PLANS AND DOCUMENTS referred to in the PDA DEVELOPMENT APPROVAL

Approval no: DEV2025/FLA/4175
Date: 06 February 2026

PROJECT
HERCULES STREET

SITE ADDRESS
19 HERCULES ST HAMILTON, BRISBANE QLD 4000

CHECKED	AA	DATE	2/12/2025	PROJECT STATUS	DEVELOPMENT APPLICATION
DRAWN	RL	SCALE	1:200 @ A1 A3@50%	DRAWING TITLE	VIEW CORRIDOR AXIS

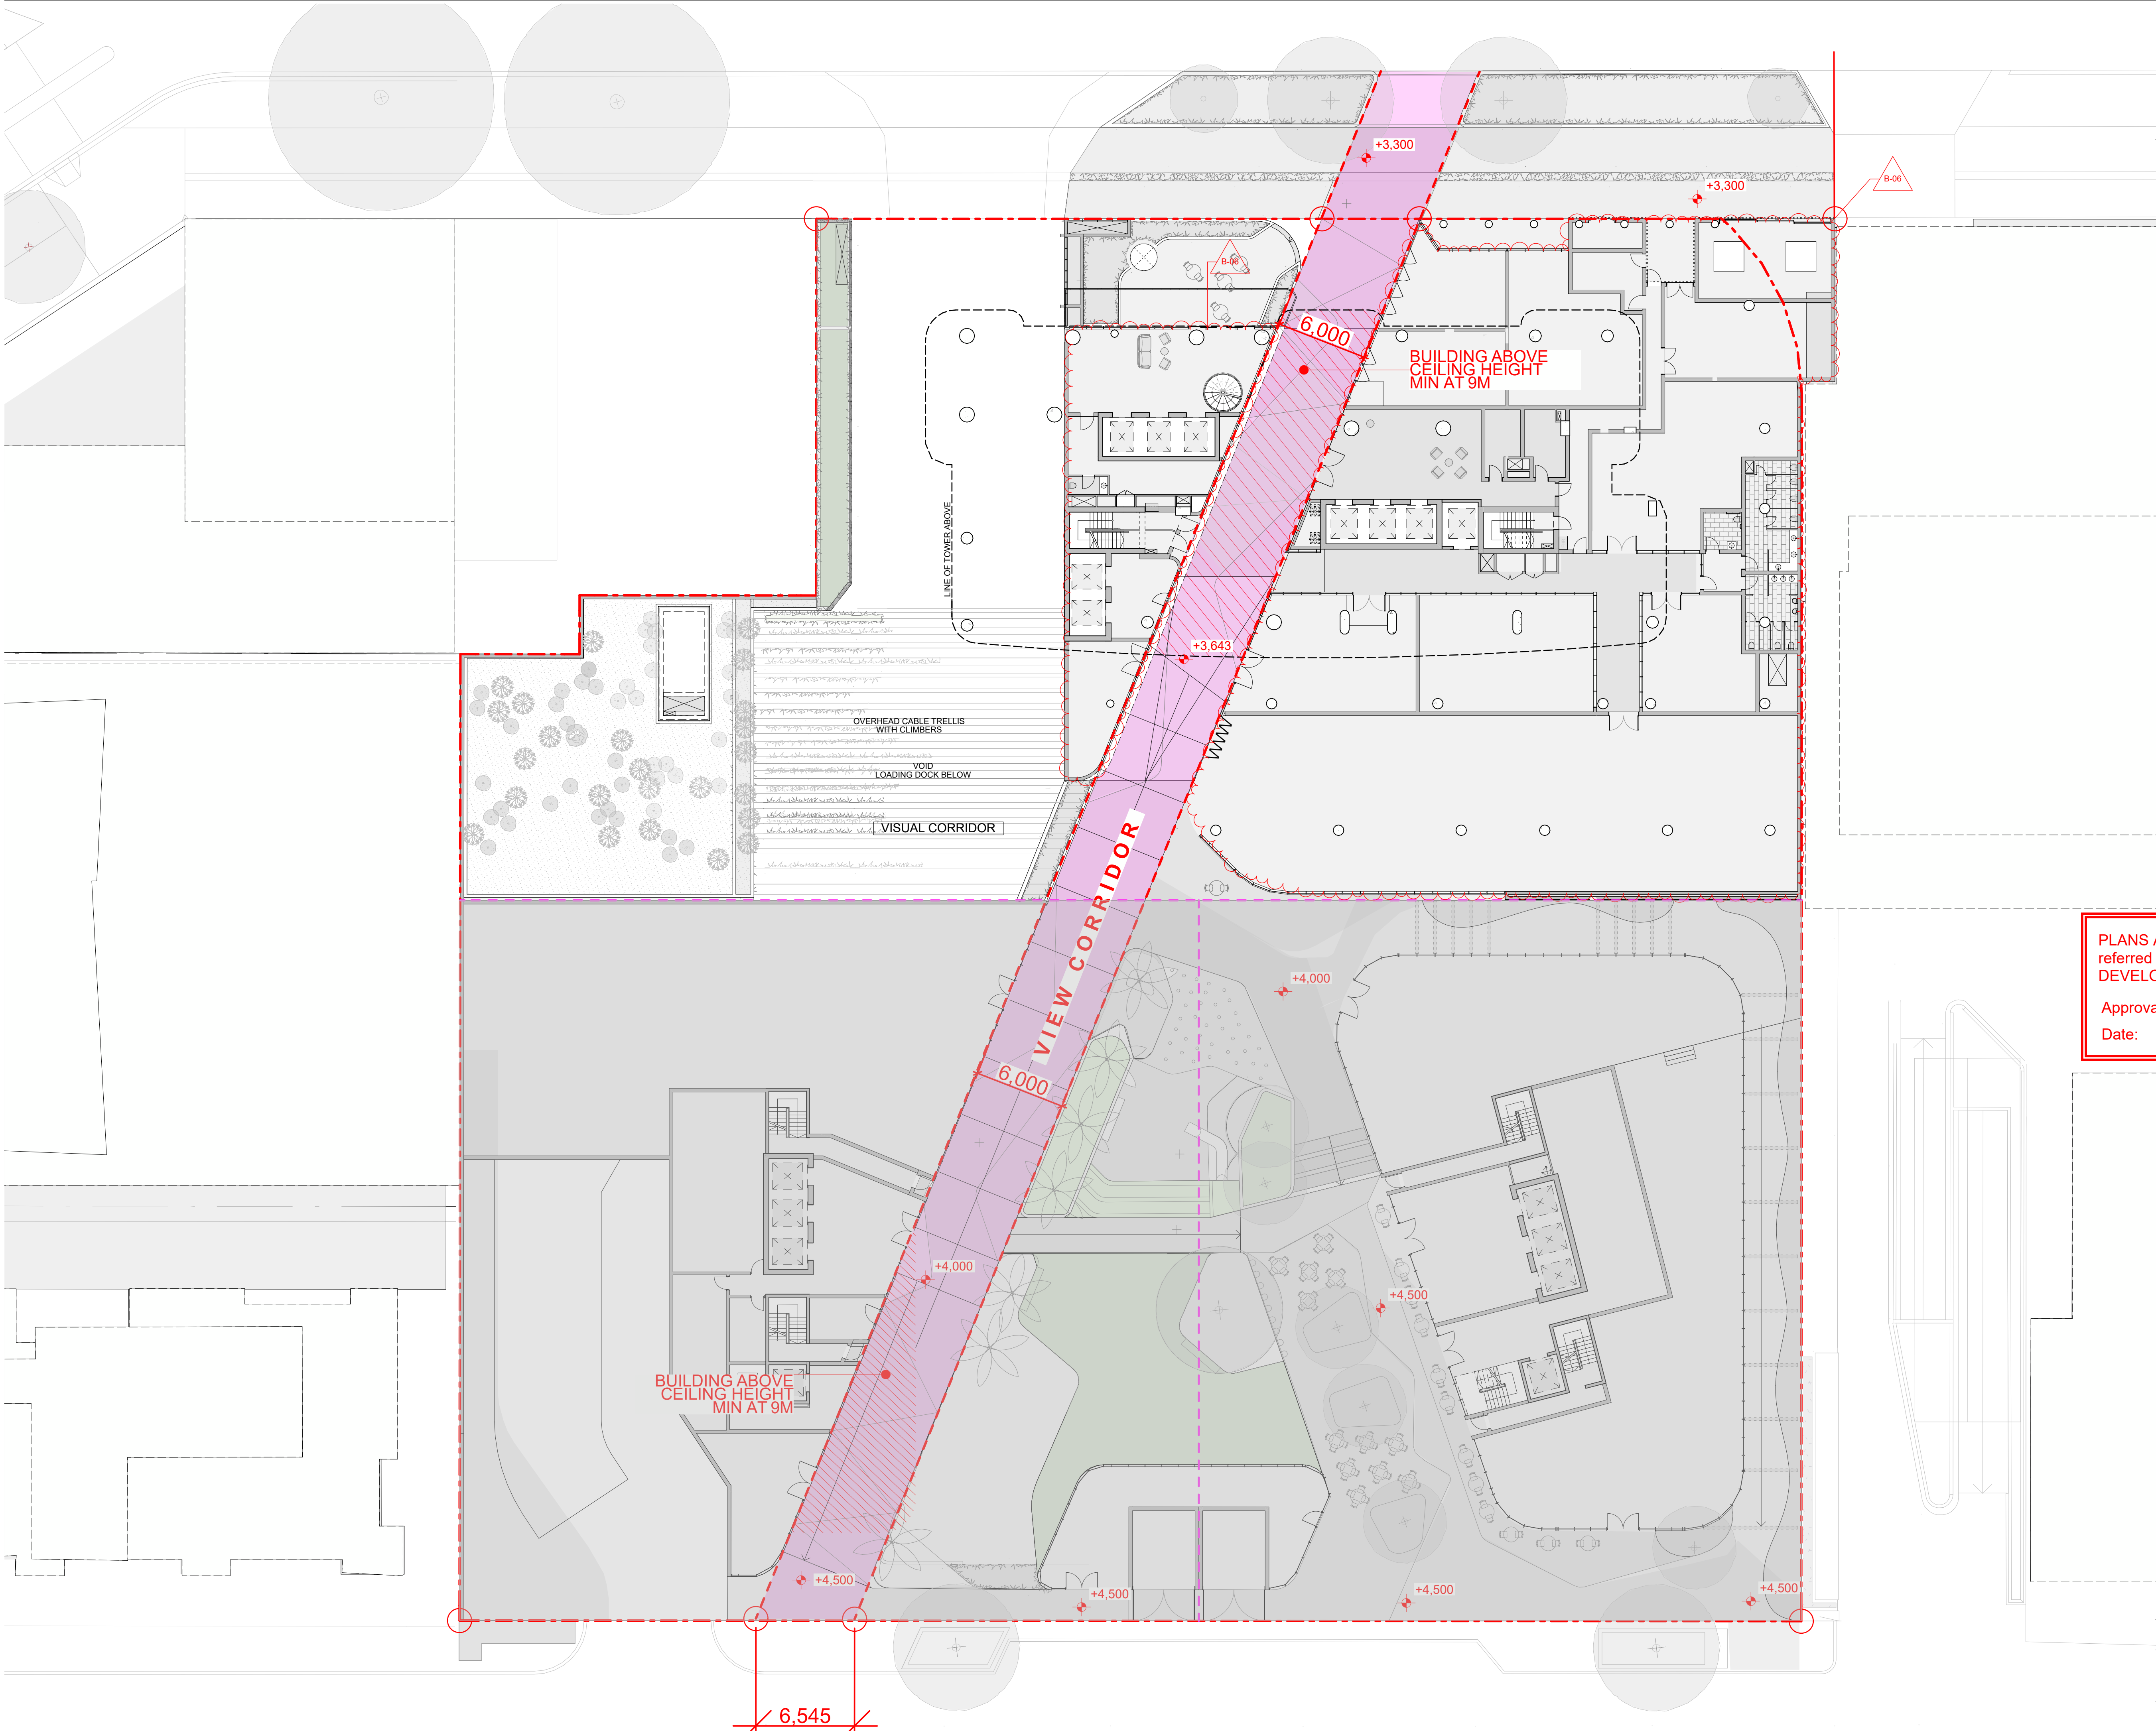
CHANGE	DESCRIPTION
B-06	BACKGROUND UPDATED, NO CHANGE TO VIEW CORRIDOR INTENT

PROJECT
HERCULES STREET
SITE ADDRESS
19 HERCULES ST HAMILTON, BRISBANE QLD 4000
JOB NO
1944
CHECKED
AA
DATE
4/12/2025
PROJECT STATUS
DEVELOPMENT APPLICATION
DRAWING TITLE
LEVEL 1 - 10 (HOTEL FLOORS)

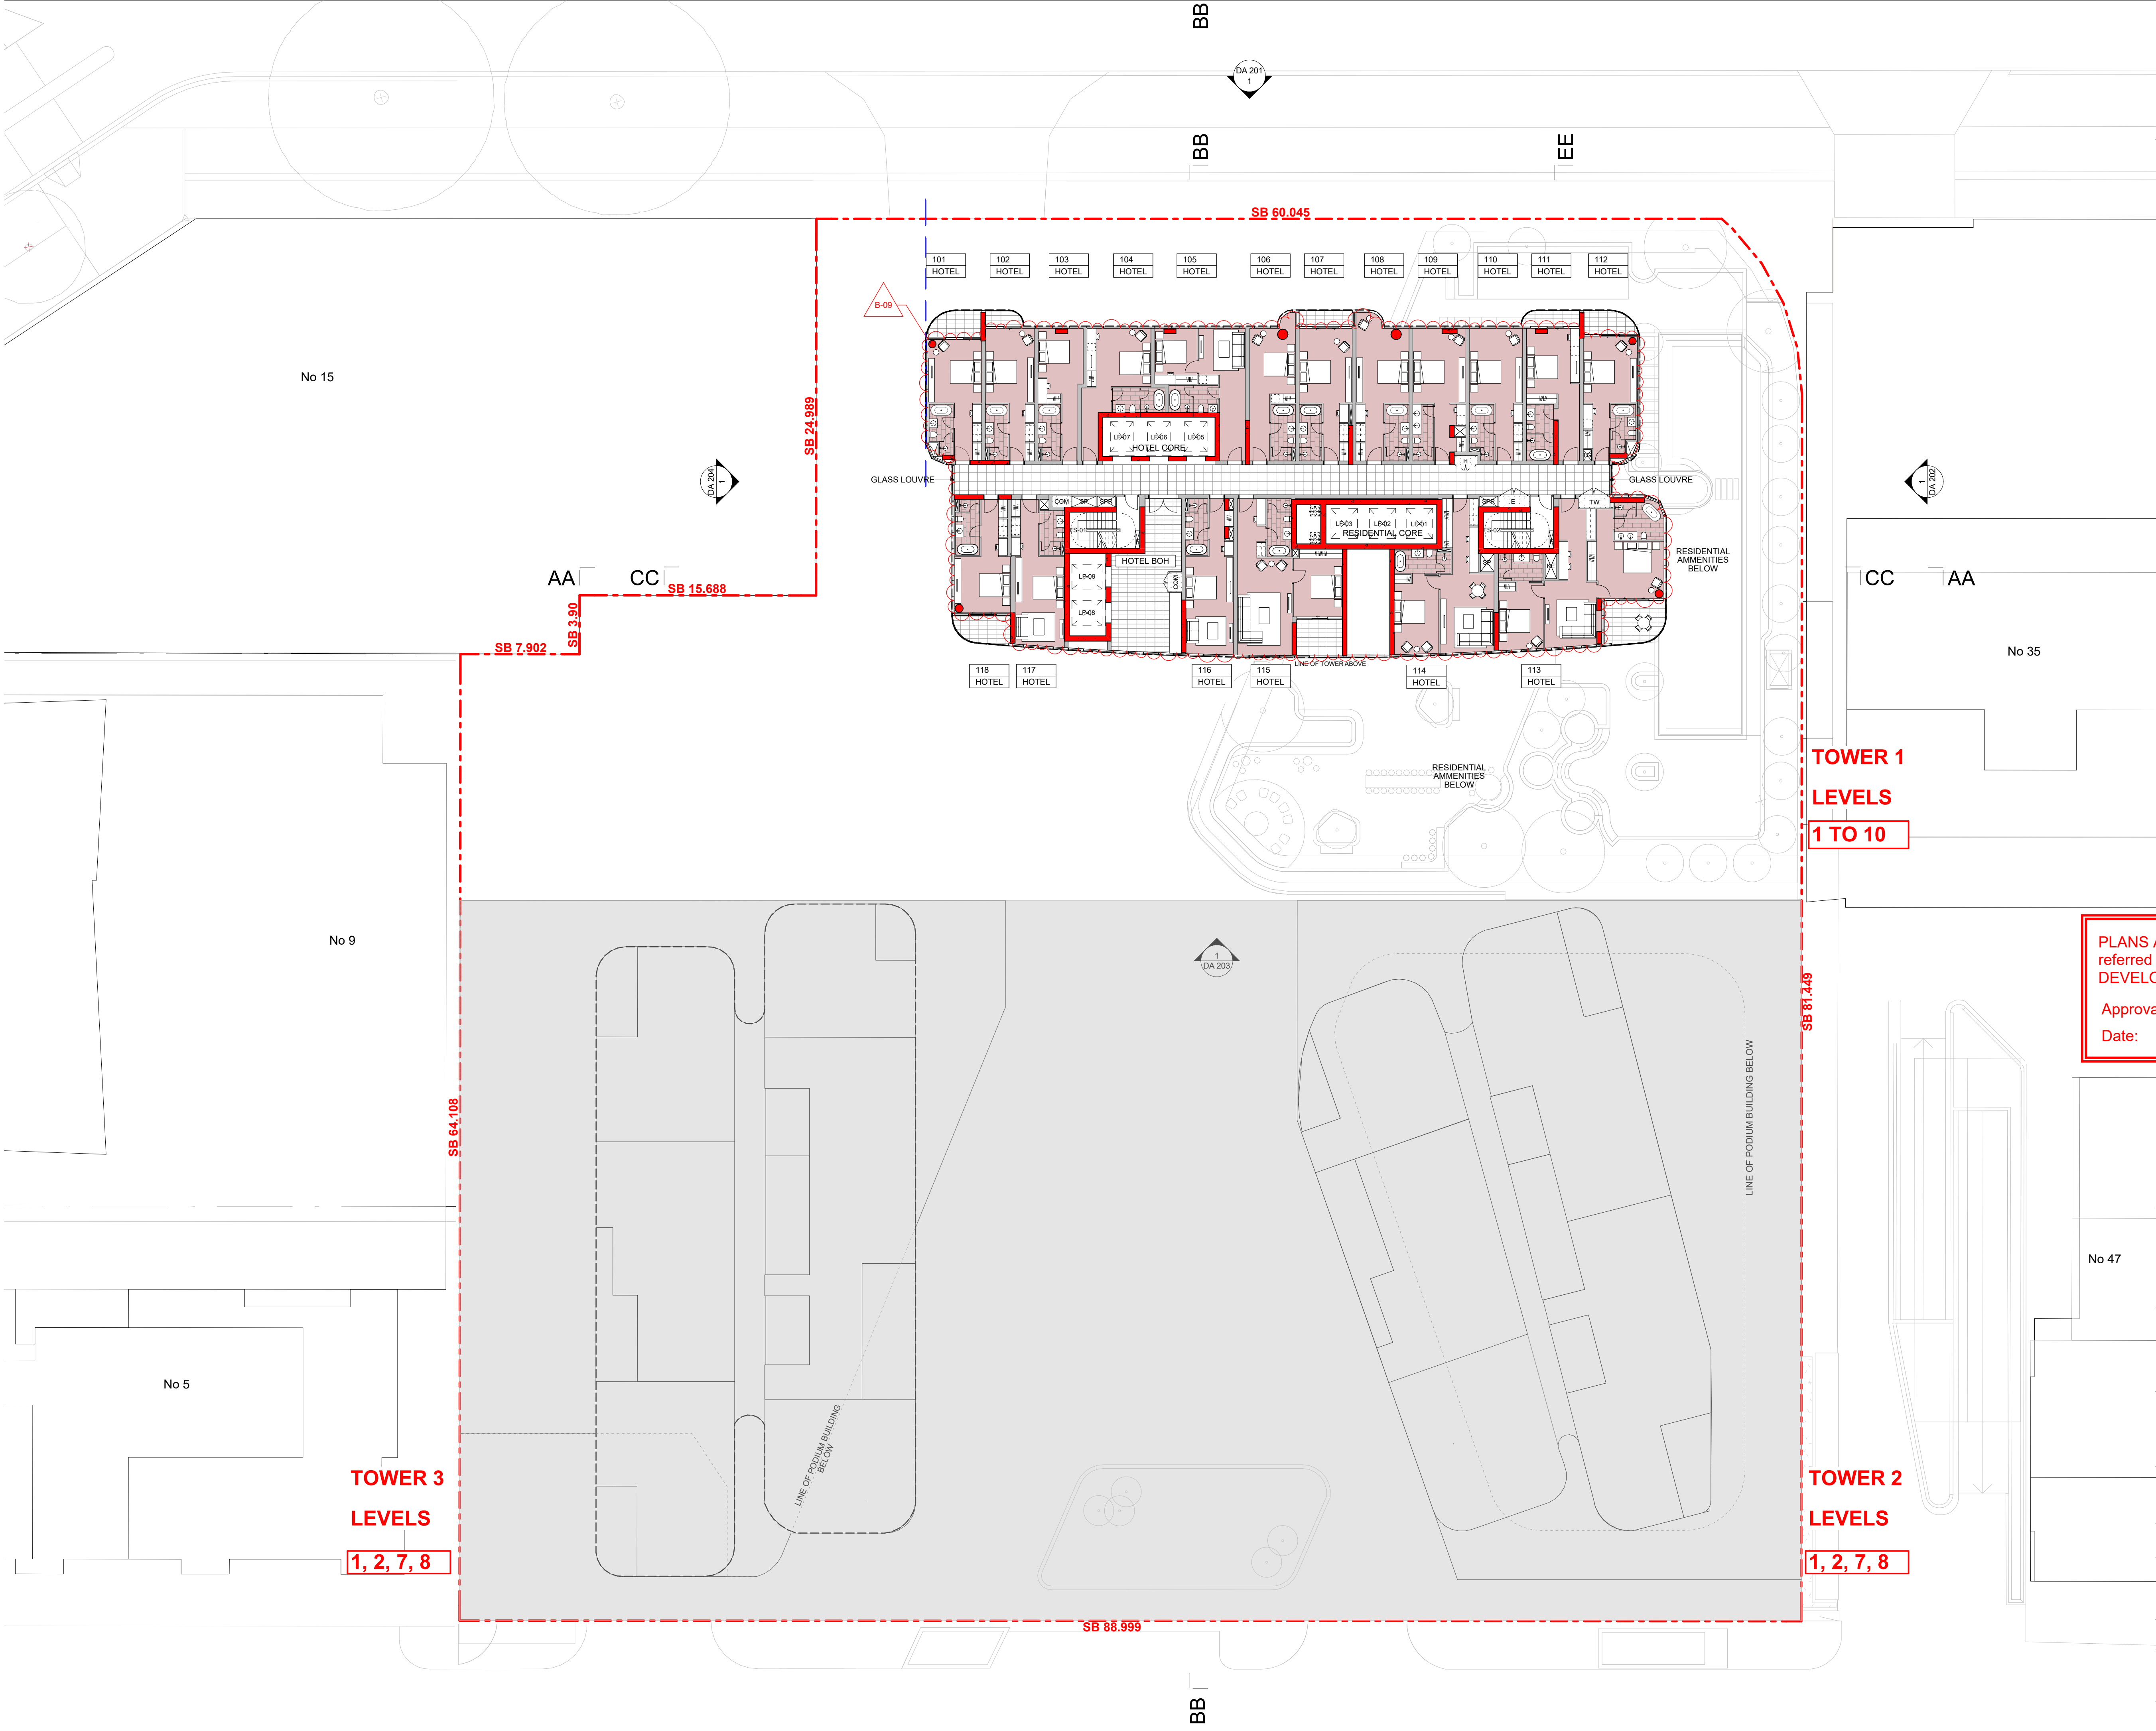
CHANGE	DESCRIPTION
B-09	CHANGE OF USE TO HOTEL FROM L1-L4-10 (SKY GARDEN CONVERTED TO HOTEL USE)

DRAWING TITLE
LEVEL 11

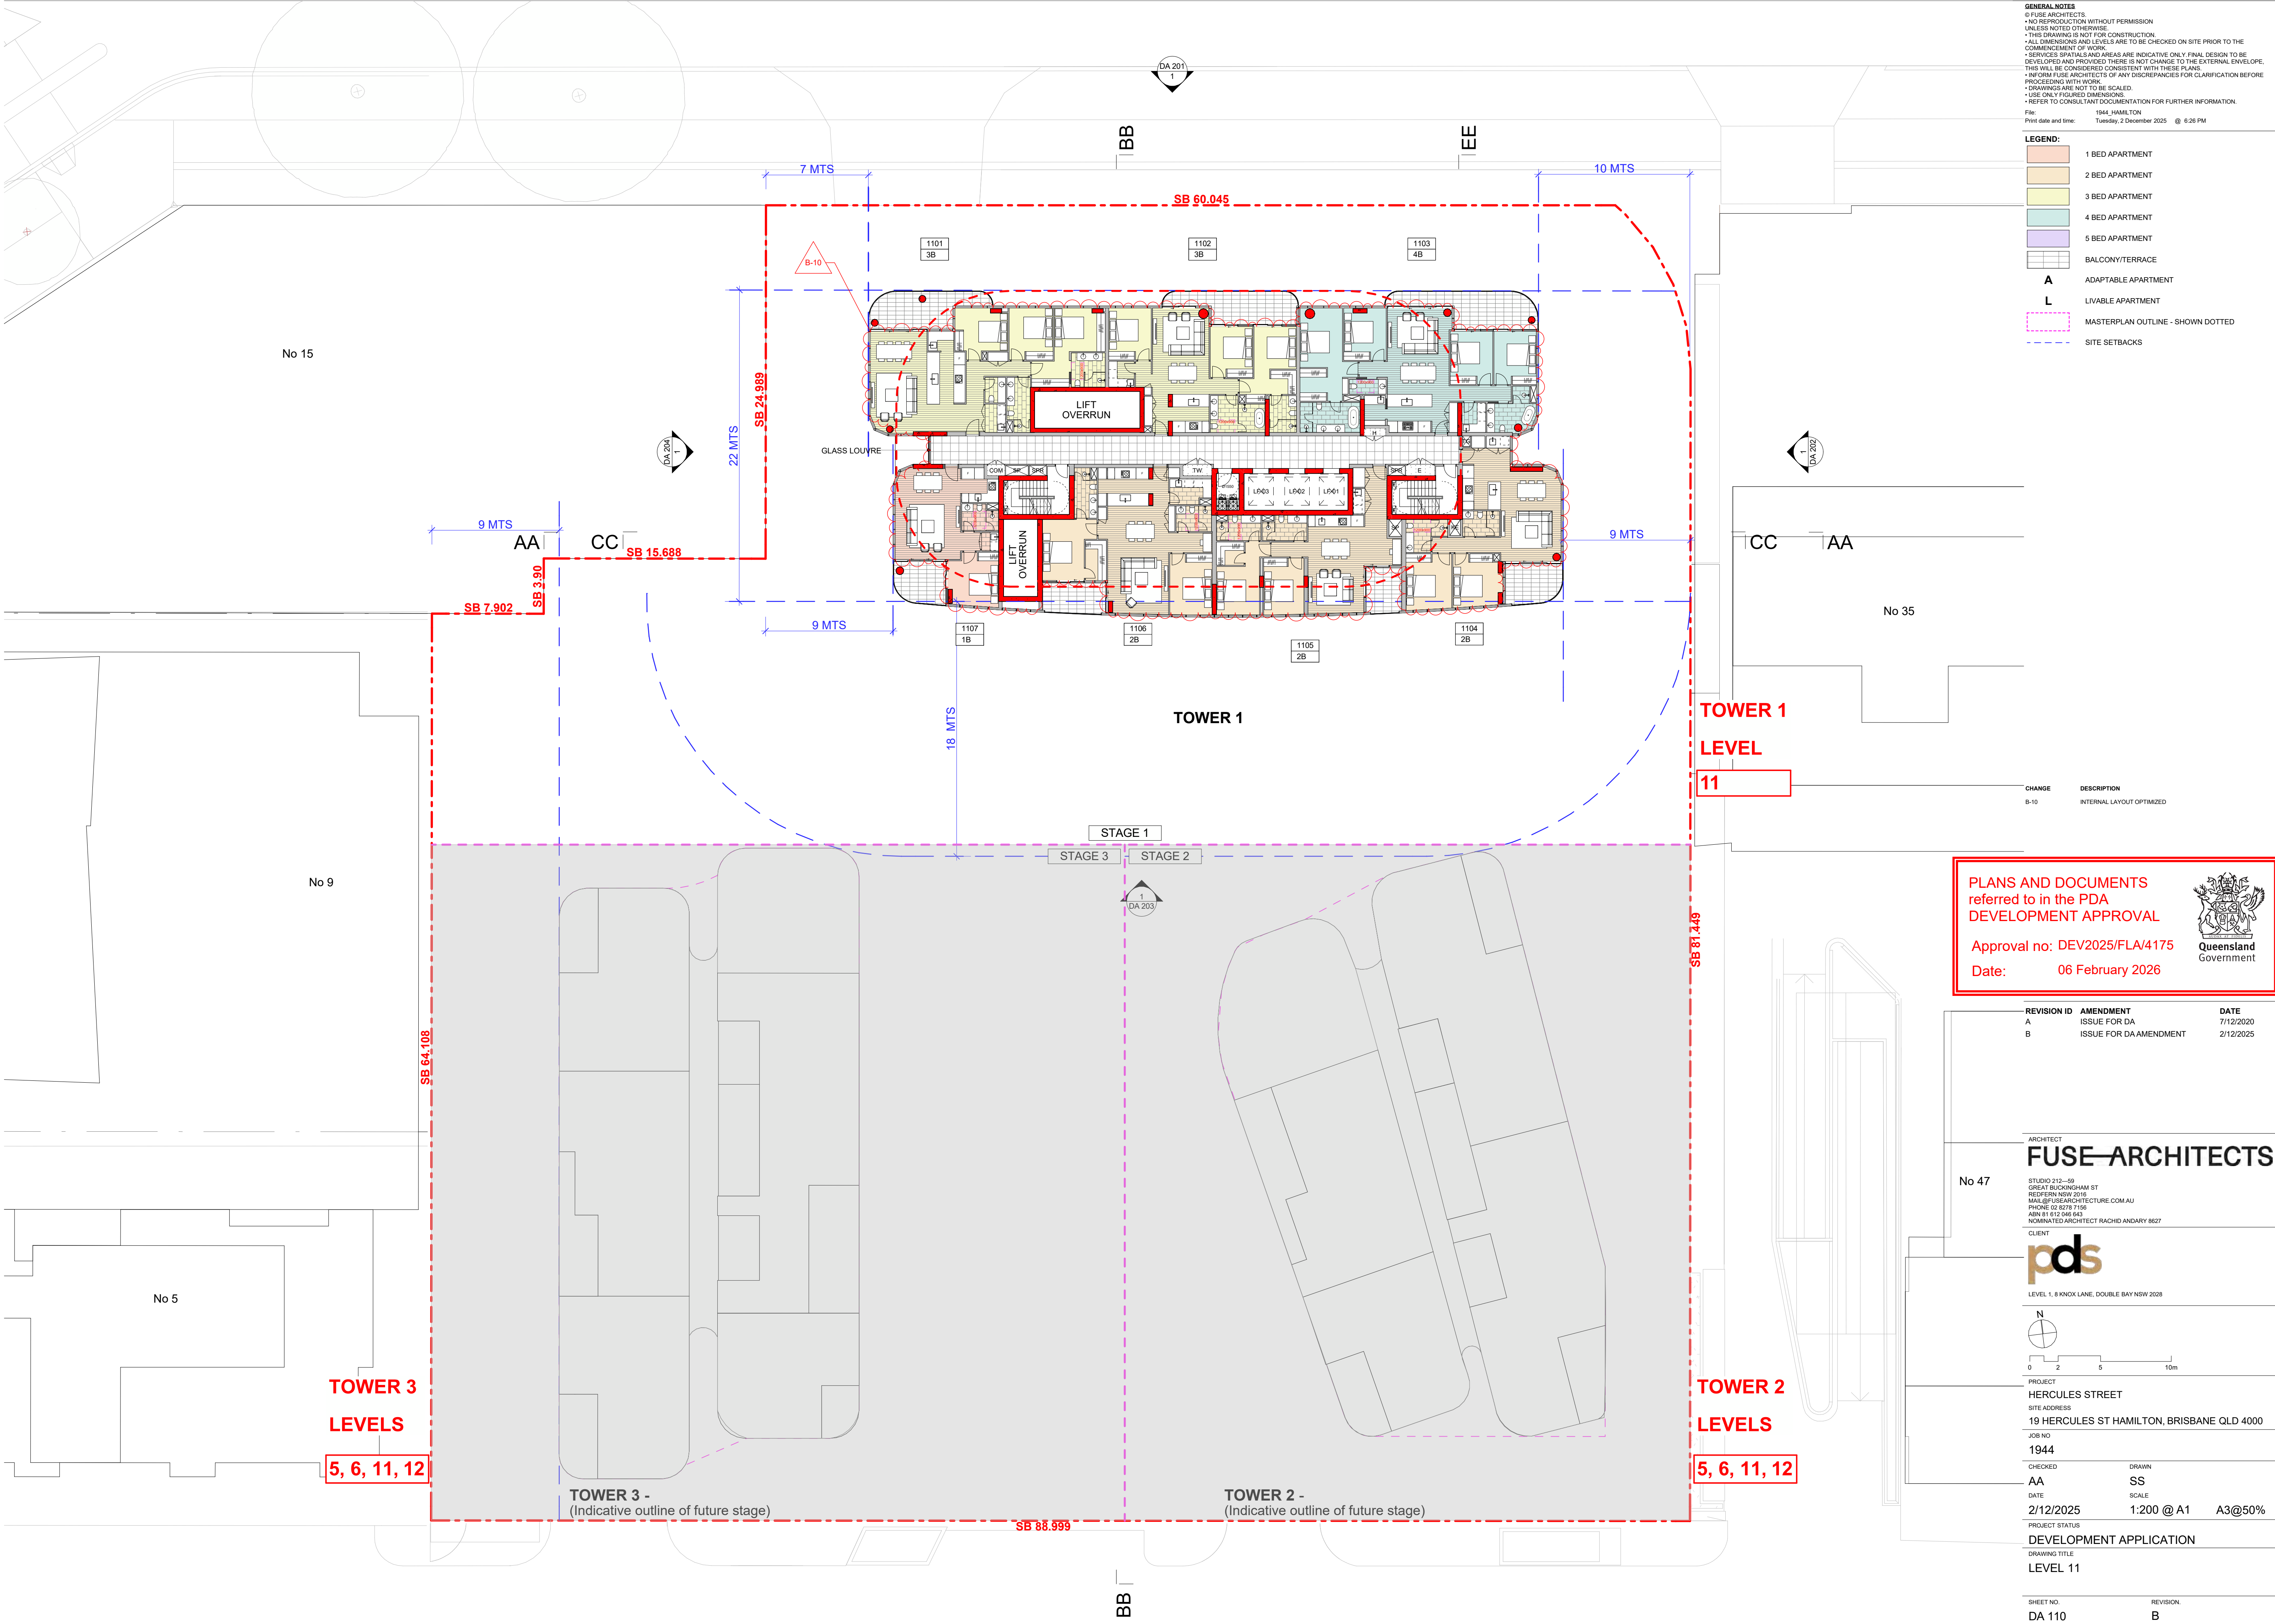
CHANGE	DESCRIPTION
B-10	INTERNAL LAYOUT OPTIMIZED
